SAFETY EVALUATION BY THE OFFICE OF NUCLEAR REACTOR REGULATION
REGARDING LICENSE AMENDMENT NO. 180 TO
RENEWED FACILITY OPERATING LICENSE NO. DPR-22
FOR MAXIMUM EXTENDED LOAD LINE LIMIT ANALYSIS PLUS (MELLLA+)
NORTHERN STATES POWER COMPANY
MONTICELLO NUCLEAR GENERATING PLANT
DOCKET NO. 50-263

ADAMS Accession No. ML14087A013

Figure 1 - MELLLA+ Operating Domain

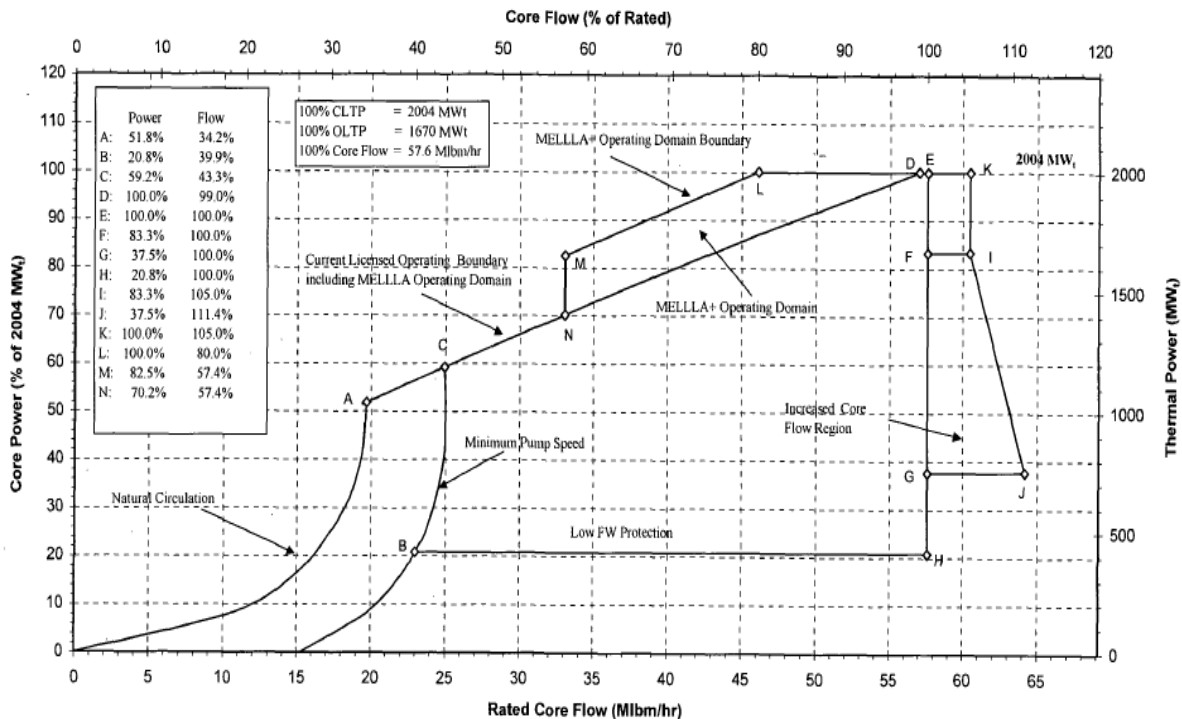
At the MELLLA+ low corner (Point M of Figure 1), the power-to-flow ratio is maximized and there is the potential to encounter void formation in the bypass region. In RAI-03, the NRC staff requested that the licensee provide an assessment of bypass void formation at point M. Furthermore, the staff requested that the licensee determine the effects of bypass void formation on local power range monitor (LPRM). The evaluation was performed and the bypass void fraction is expected to be less than 3.4 percent. This value is calculated using the ISCOR hot channel methodology computer code, which is conservative because it neglects cross flow between bundles in the bypass region; thus, the bypass voids are expected to be lower than the 3.4 percent value calculated. Proper LPRM calibration requires that the bypass void be maintained to a value less than 5 percent; as such, the NRC staff concludes that bypass voiding under MELLLA+ conditions in MNGP do not affect the LPRM instrumentation adversely.

RAI 9/11/13-2

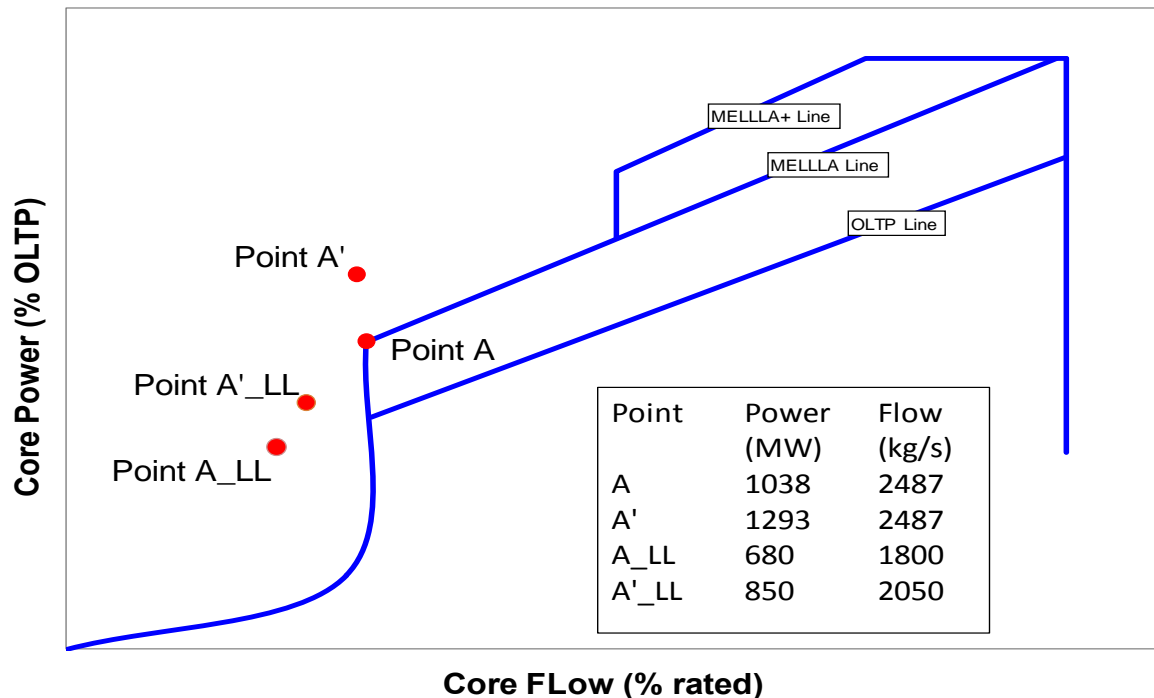
Providing an ATWSI analysis is a MELLLA+ SER requirement per NEDC-33006P-A, Rev. 3, but the ATWSI analysis of record in the Safety Analysis Report (SAR) is based on the incorrect TRACG04 quench model. Provide documentation of the updated ATWSI analysis that includes assumptions, sequence of events, plots of relevant variables, and margin to acceptance criteria. Provide a justification for the assumptions used, with special emphasis on operator action timing (including actual timing values from simulator trials) and the type of initiating transient selection (i.e., Recirculation Pump Trip (RPT) versus Turbine Trip with Bypass (TTWBP)). A SAR revision or update would be adequate.

Documentation of the updated ATWSI analyses was provided for both the TTWBP and the new limiting event, the 2RPT. Sequence of events, figures and description of the transient were provided as “changed pages” for the SAR. The NRC staff considers this RAI closed.

Figure B-2: Operating Points Analyzed

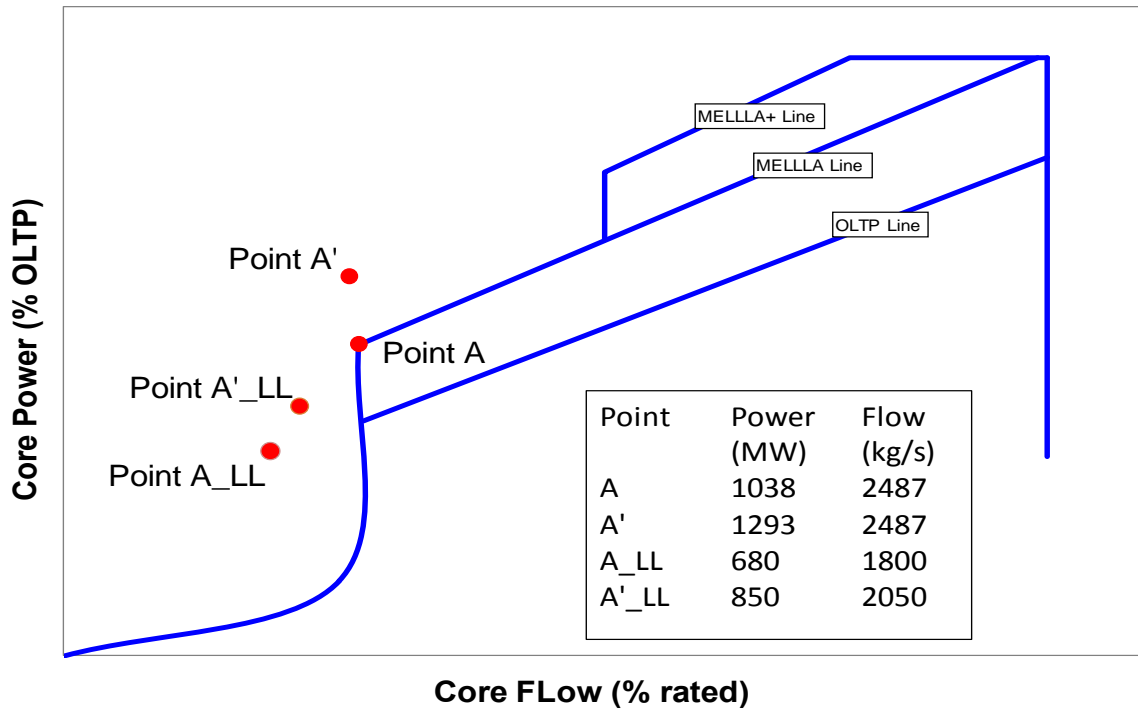
To determine the operating conditions of Point A' _LL, a number of iterations were performed with LAPUR6. To determine the flow, a series of LAPUR6 calculations were performed as function of flow and the core delta-pressure was calculated. A reduction of downcomer water level to 2 feet below the spargers is equivalent to a 1.5 meter level reduction (at MNGP, the spargers are located at a reactor water level of -33 inches). At the reactor operating pressure, a reduction of 1.5 meters is equivalent to a pressure drop of approximately 0.1 bar. Thus, LAPUR6 runs were iterated until the core pressure drop calculated at Point A' (0.47 bar) was reduced to a value of 0.37 bar. To determine the operating power, the core-average void fraction was matched by iterating on the power level. Point A' has a core-average void fraction of 64.3 percent. The power of Point A' _LL was changed until the same void fraction was achieved, indicating that the core would be critical (i.e., $k_{eff} = 1$) at this power level. Note that LAPUR6 computes the power-square average of the void, which is a better approximation in determining $k_{eff} = 1$ than the non-weighted average.

Point A _LL represents the low-level state for the pre-MELLLA+ core, where the downcomer water level has been reduced to 2 feet below the FW spargers and the core-inlet temperature is at saturation.

The result of the iterations shown in Figure B-2 and Table B-3 corresponds to a power of 850 MW and a flow of 2040 kg/s for point A'_LL, and 680 MW and 1800 kg/s for point A_LL.
